ENGINE EXHAUST SYSTEM

GENERAL INFORMATION

1. MAJOR CHANGES

RODIUS 2013.02

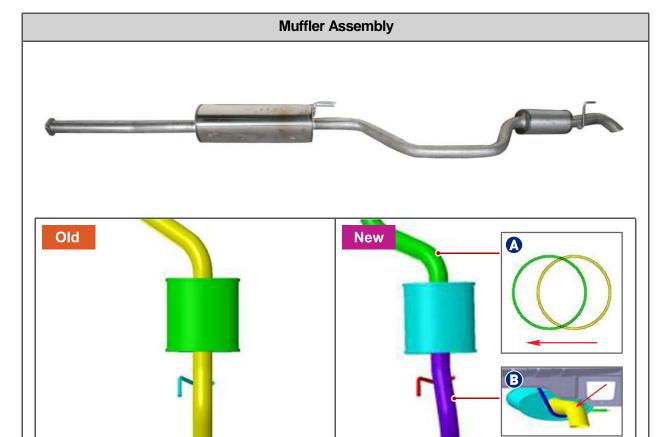
- Muffler assembly parts (A, B) changed due to change of rear subframe
 - (A) Connecting pipe between muffler and tail silencer: moved by 20 mm
 - (B) Gap between tail silencer pipe and body: changed from 16 mm to 25 mm
